From: Jacques van der Merwe <Jacques.VanDerMerwe@capetown.gov.za>
Sent: Monday, 06 June 2022 12:08
To: gavin.george
Cc: Clifford Dorse; Monique Owies; Jaco.Damarakloof@gmail.com
Subject: Farm Portion 3/719: MULDERSVLEI 300M² RESERVOIR AND ASSOCIATED INFRASTRUCTURE - notice of intended site visit for engineering survey/geotechnical investigations
Attachments: Habitat condition map.png

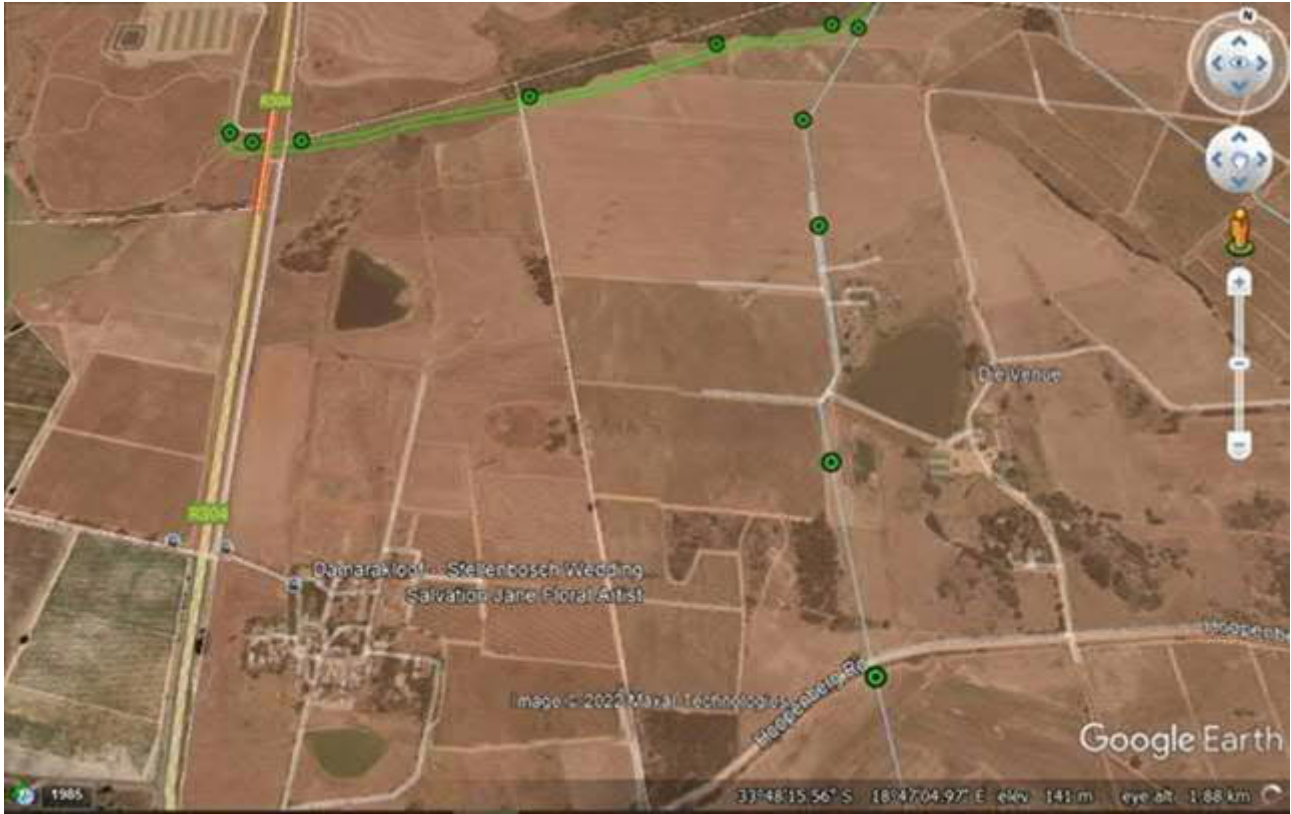
In terms of the geotechnical investigations, the image below indicates only one point (green circle) on your property, which is a trial pit.
